# CITY OF ALBUQUERQUE

**RE: Westgate Community Center  
10001 DeVargas Rd SW  
Conceptual Grading and Drainage Plan  
Engineer's Stamp Date: 11/30/18  
Hydrology File: M09D030**

Based on the submittal received on 12/3/18, the Grading and Drainage Plan cannot be approved until the following corrections are made:

Re: Westgate Community Center: M09D030  
COA Hydrology Site Plan for Building Permit Approval Re-Submittal

C-001

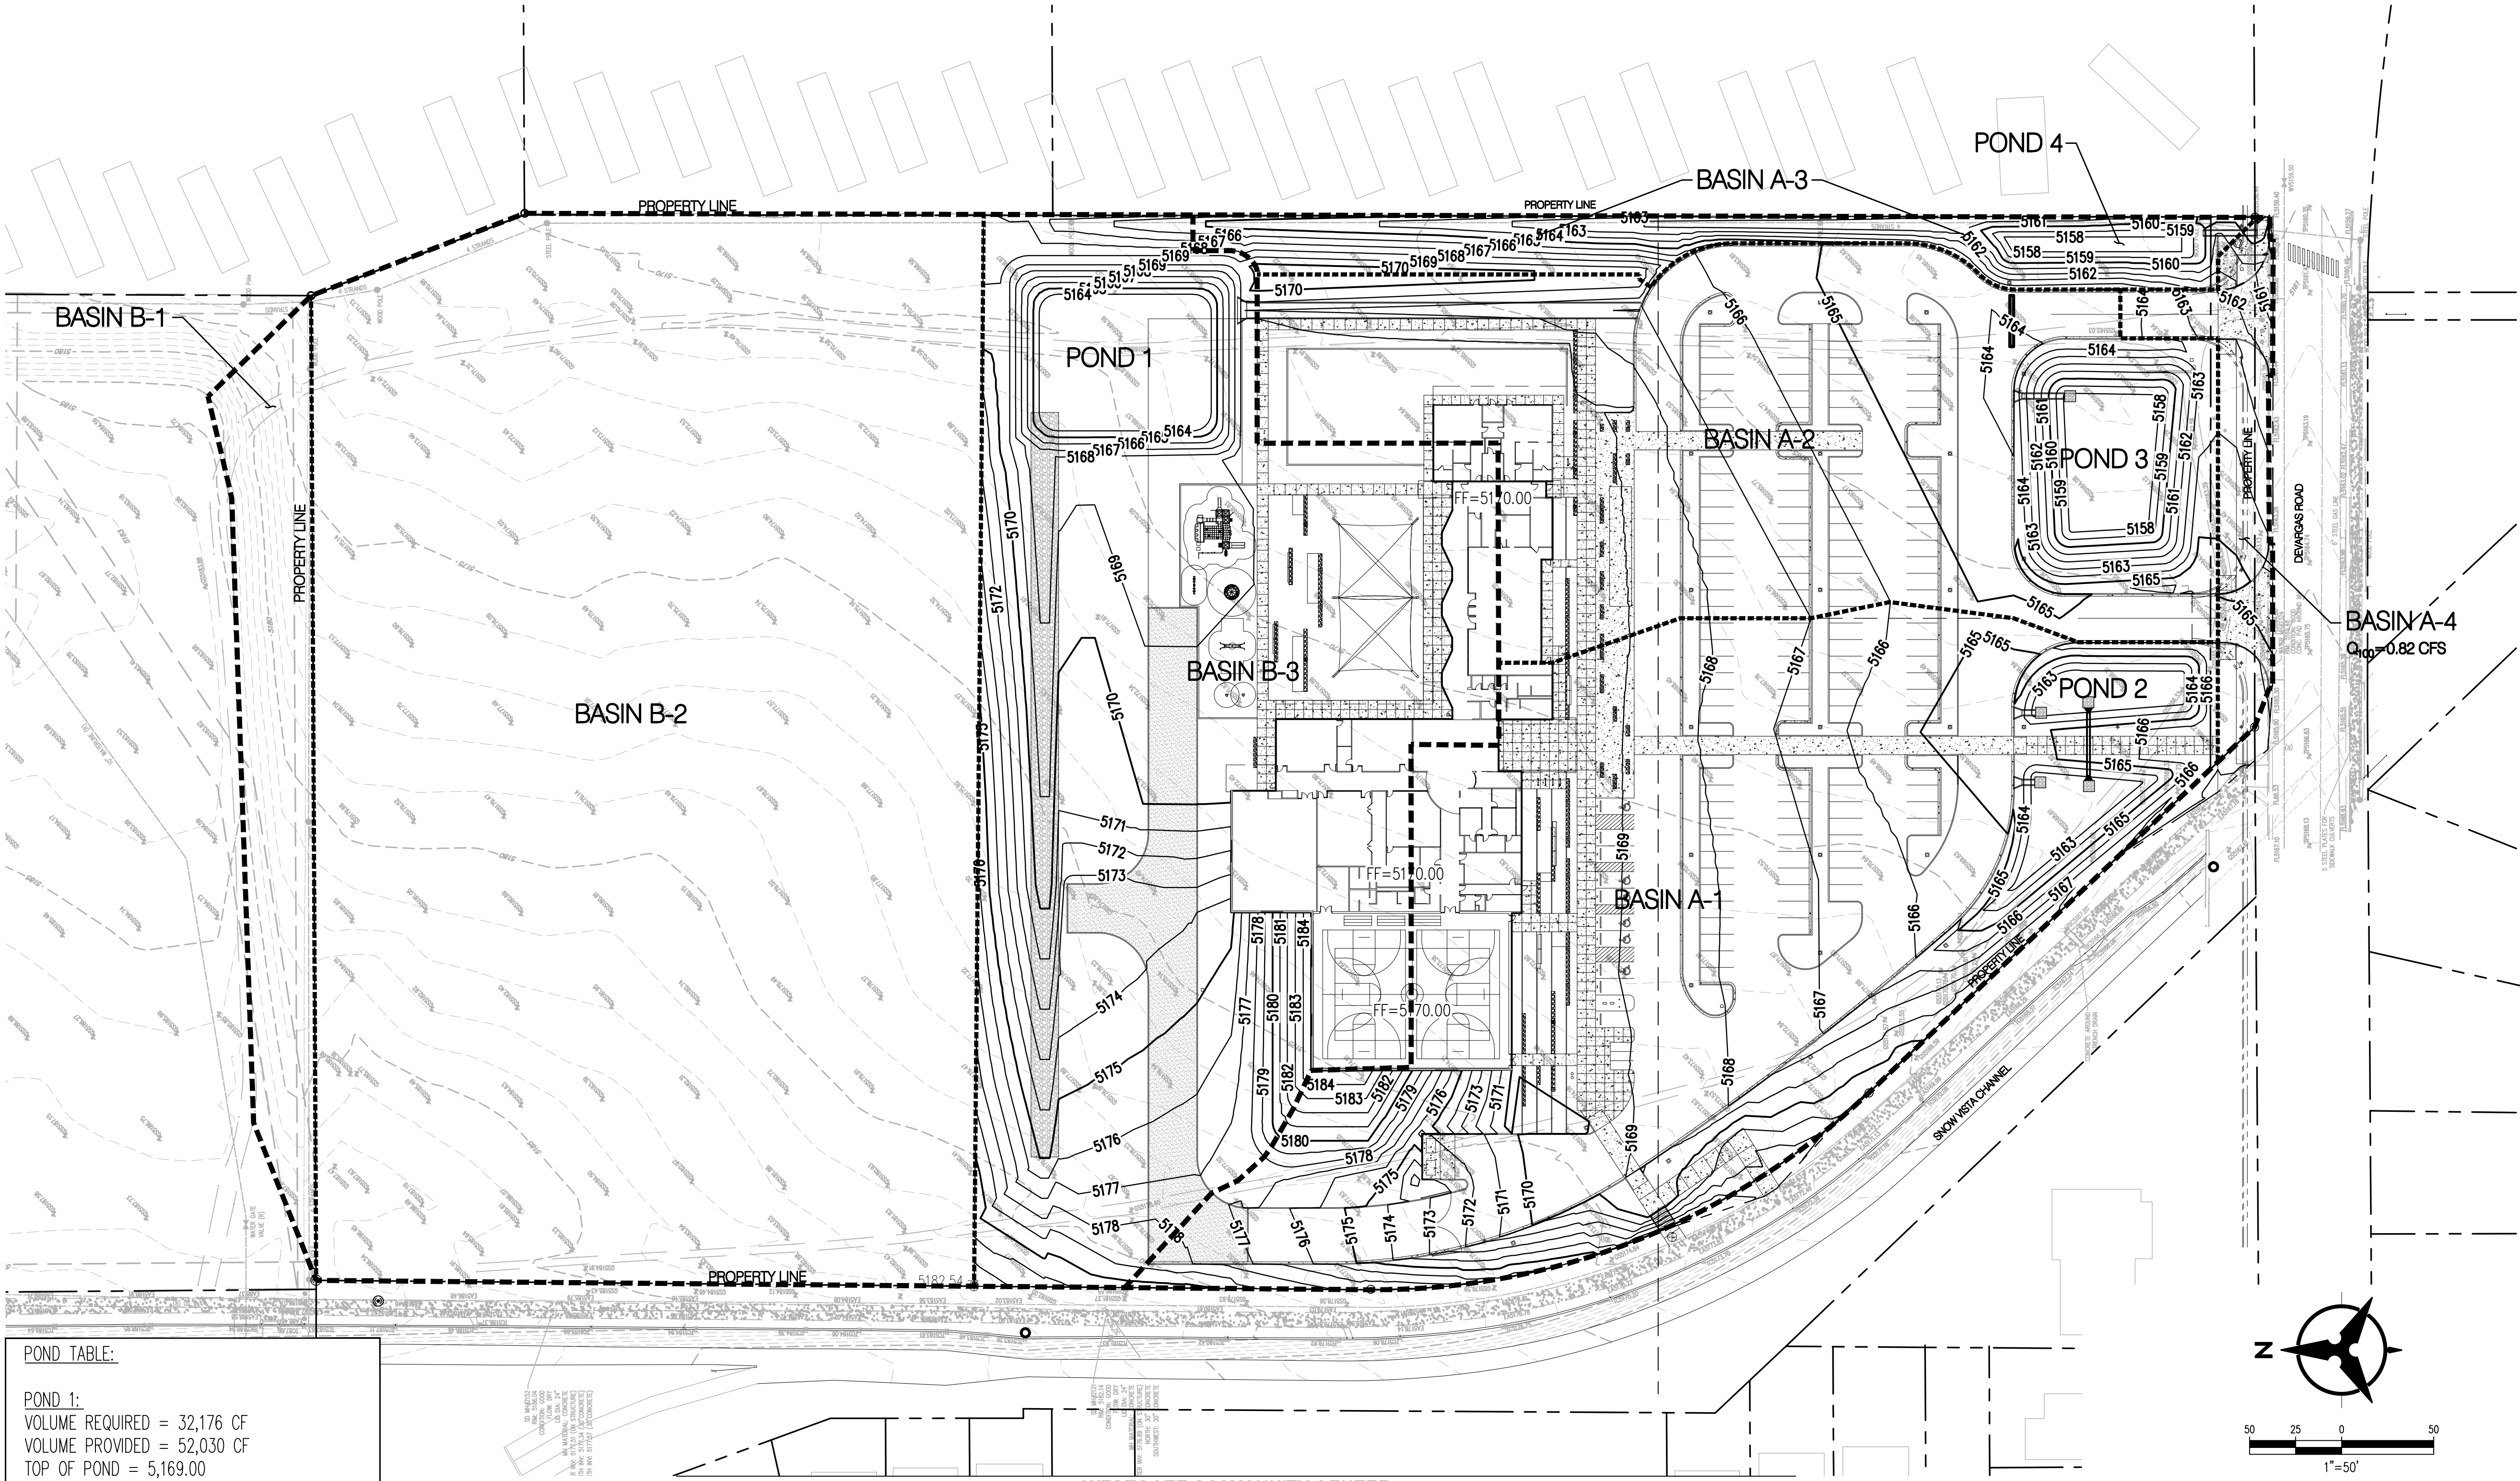
1. Specify Std Dwg 2260 for the ribbon channels.
2. Because Pond 4 retains more than the 100-yr, 10day volume for the contributing area, it doesn't need an emergency spillway (the channel out to DeVargas). This should be removed as it conflicts with the proposed and future built-outs of DeVargas and its sidewalk.
3. Correct the grading around the SE corner of Pond 4, especially the 5160' contour.

POND 4:  
VOLUME REQUIRED (100YR-10DAY) = 1,321 CF  
VOLUME PROVIDED = 3,185 CF  
TOP OF POND = 5,160.00  
MAX WATER SURFACE ELEVATION = 5,159.20

C-100

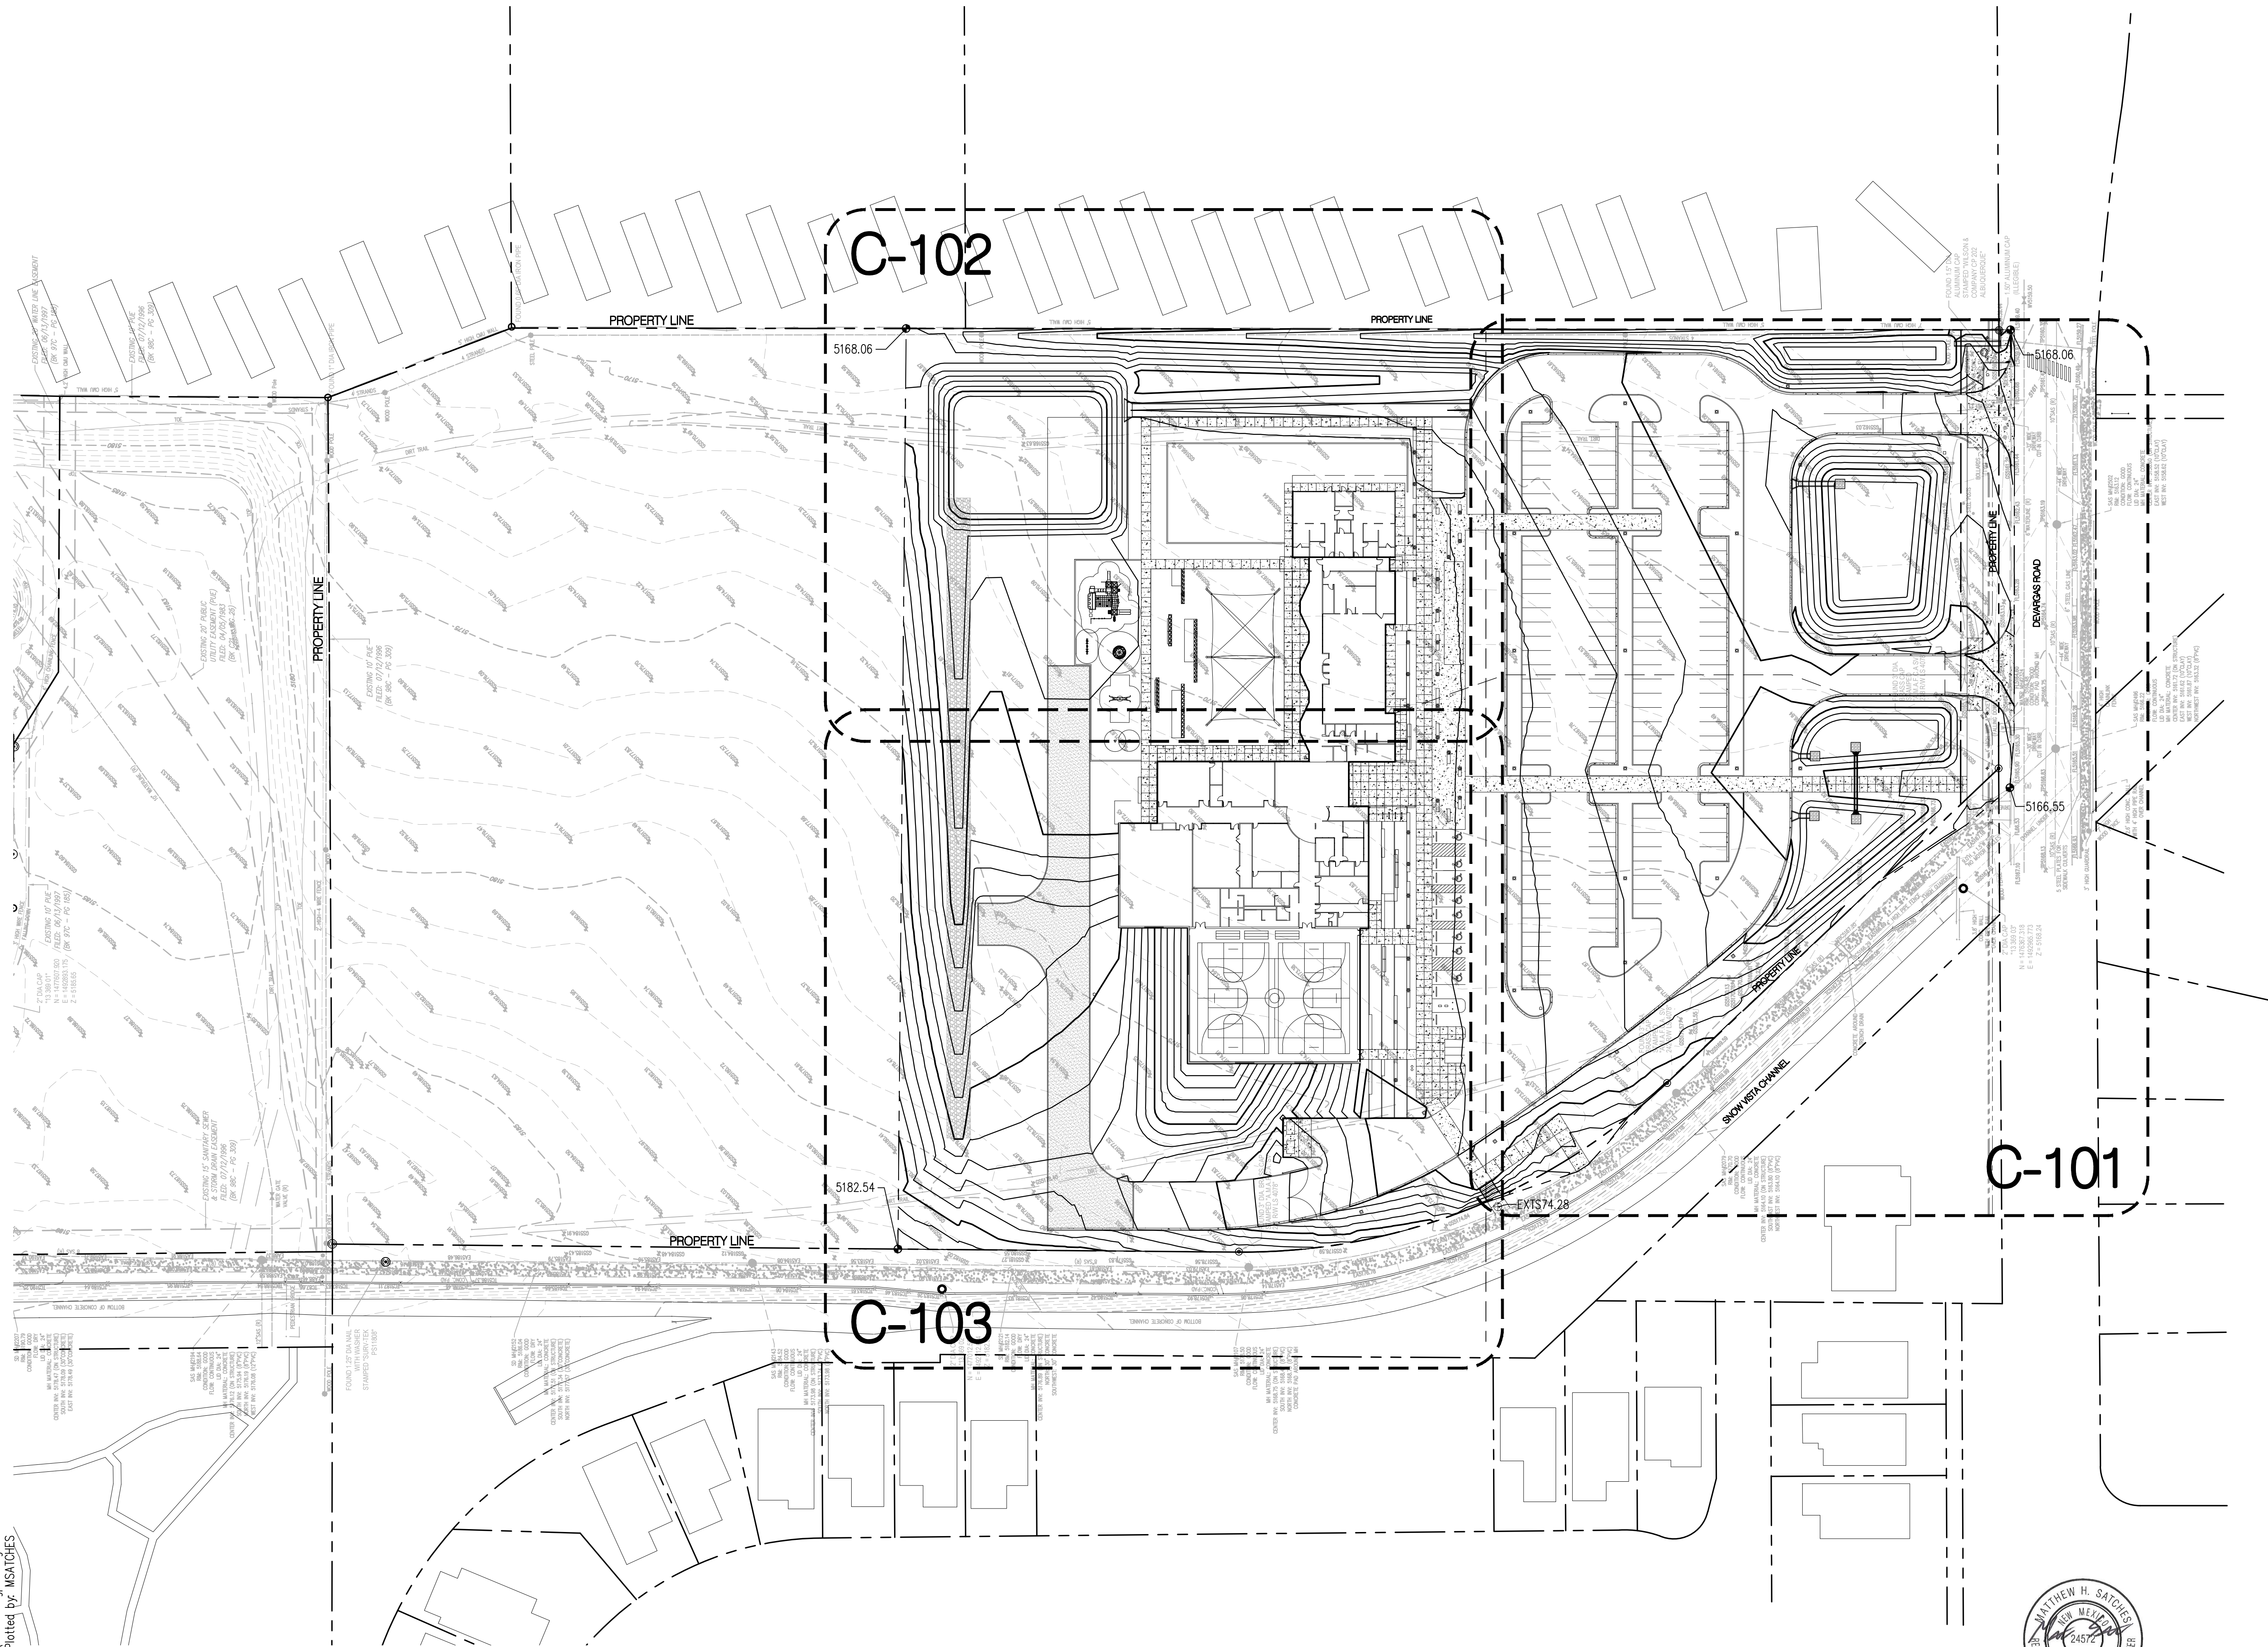
4. Provide hydraulic calculations for the riprap swale along the north side of the project and the concrete rundowns into ponds 2 and 3.
5. Include a note that *no work shall be allowed in the public ROW without an approved Work Order*.
6. Will the basin B-2 area be used for staging? It needs to be reseeded if so; specify reseeding per section 1012 for all disturbed areas.
7. Depress the landscaping in the parking islands to provide additional water quality and allow water to enter the islands instead of ponding/ backing up in the parking spots.
